Minutes of the Design Review Panel Meeting 1 – July 7, 2015

The Design Review Panel met on Tuesday July 7, 2015, in Committee Room 2, Toronto City Hall, 100 Queen Street West, Toronto, at 11:30am.

Meeting 1 Index

53-65 Ontario St and 102 Berkeley St	
Design Team	Architects Alliance
Review	First Review
Application	Rezoning
City Staff	Henry Tang, Community Planning Myron Boyko, Urban Design
Conflict of Interest	none
Vote	Refine – 1; <u>Redesign - 8</u>

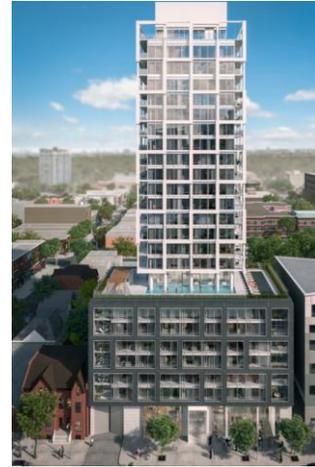
The Panel is concerned about the design intent of this submission. Within an older neighbourhood every new building must be sensitively and positively additive to that neighbourhood. Further design work is needed in order for this submission to achieve this goal.

- decreasing density
- reducing podium and tower height
- improving setbacks and built form proportions
- shifting to a more solid materiality

It was recommended that the base building be lowered by the majority of Panel members with more visual relationship to the scale of the north heritage building. In addition, a suggestion was made to "give the corner of the Victorian building back to the public realm" by providing more room around it. It was noted by several members that the lower base would also better relate to the context across the street.

- It slams up to the building on the north – it's cramped
- the building to the north needs more room, materially and scale needs reference
- I struggle to justify the height of the podium itself – it doesn't feel like it's the right height – too tall
- There should be either a midrise here with 2 storeys on top, or it's a tower with a lower base
- An 8 storey blank wall is not acceptable
- There should not be a party wall condition to the north building – there should be a response

Panel were concerned with the reduced setbacks of the tower noting the potential for cumulative negative impacts for the area and "too close" conditions with adjacent neighbouring properties. Several Panel members further questioned whether the site was large enough to support a tall building. In addition, the lack of adequate open space and outdoor amenity provisions was noted by one member.

- It squeezes too much into the site – overly ambitious density for the site
- Setbacks are too small – if there is a building in the future at the east, it will be too close
- A big issue in the city is putting towers on small sites – 12.5m [setback] is a minimum standard, not the ideal
- Look at if the neighbour can do the same thing and is it desirable cumulatively?
- If there are only a few sites on the block that could have height, the applicant should show how it could be built out. Then you could develop a rationale for the 9m setback if the adjacent site does not develop for some time.
- The quality of life infrastructure such as gardens and spaces with light: is this [project] complete enough? The site is completely filled.

4208 Dundas St West	
Design Team	Wallman Architects
Review	First Review
Application	Rezoning
City Staff	Julie Bogdanowicz, Urban Design
Conflict of Interest	none
Vote	Refine – 1; <u>Redesign - 8</u>

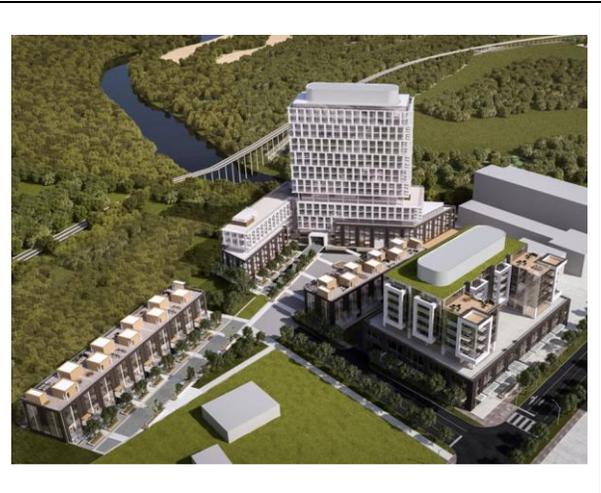
- developing design to interweave throughout the site natural landscape environment context and built form into a permeable, interconnected "buildings in a park" strategy
- considering joining Blocks 1A and 2, creating a single larger landscaped courtyard area to the north
- considering tightening gap between Blocks 1B and 1C, resulting in more open space at northwest end of site
- with the above taking into account open space contribution to broader precinct goals

Members also focused on possible improvements to the disposition of elements framing the central open space to make it successful. The Townhouse Block 1A was of particular concern, with most members suggesting that it felt incongruous and should be removed, or moved back significantly to open up an important central space. A specific comment on the project was that "a good central open space between mid-rise and tower would give it a visual focus which it lacks at the moment" and that the open space proposed felt "residual" and not fully developed. It was also recommended that instead of a cul-de-sac, the removal of the townhouses could allow for a looped street.

With regard to the tower floorplate, Panel raised concerns as to whether or not this would be appropriate given the current design and site plan design, while not completely negating it as a possibility. Several members noted that the larger floorplate might be appropriate for this site in particular, provided that there is good access to the ravine, massing refinements to open the site up visually to the ravine, and a great central space. Several other members however were of the opinion that "the case had not been successfully made" for a larger floorplate, and that the proponent should show what a smaller floorplate would look like on the site for further evaluation.

While members did not feel that the corner needed to be addressed in an extraordinary manner, the Panel felt that the building needed more work, particularly when viewed from the corner. Appreciating that the project is still in progress, the Panel commented that the top and bottom elements need to work together and at this point, the building appears to be designed by two architects. Panel thought that much more work on the design would need to be undertaken – that the "floor-to-ceiling glass and big white frames need to evolve". One member suggested that the base of the mid-rise could be a storey taller. Panel members emphasized the importance of a successful building on the Dundas St frontage.

- This is a huge improvement of the original site plane but the tower was cooler in the first one – The tower should be cooler and curved
- The south building needs to go back to the drawing board – the top and bottom don't go together

Townhouse and Low-Rise Building Guidelines	
Design Team	City Planning
Review	First Review
Application	City-initiated Study
City Staff	Diana Birchall, Urban Design
Conflict of Interest	none
Vote	No vote

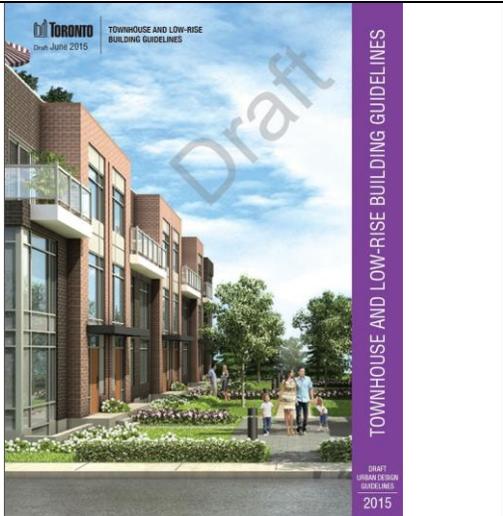
- make document graphic and direct; favouring diagrams, sketches and images, and minimizing verbage
- distill content wherever possible for clarity and directness of message to intended audience
- clearly outline requirements vs. guidelines
- ensure consistency of message of a cohesive strategy
- include ancillary items in document; such as service/loading/waste handling
- capture townhouse hybrid strategies
- include case studies; showing history, precedents and challenges/opportunities relevant to each study

The document was advised to be edited and repetitive elements removed to make it more concise and easy to use. Universal guidelines were recommended to be compiled under a general section, to avoid repeating sentences in multiple sections. (eg: mews streets should not be gated)

The final outcome of the guidelines should be clarified in terms of by-laws, building codes, standards or guidelines status. A suggestion was made to target stacked and back-to-back townhouse issues in particular and that more general planning issues such as transition in height should be removed.

-Care should be taken to avoid contradictory images and text. For example, there is language regarding universal accessibility but photos and figures show mostly stairs.
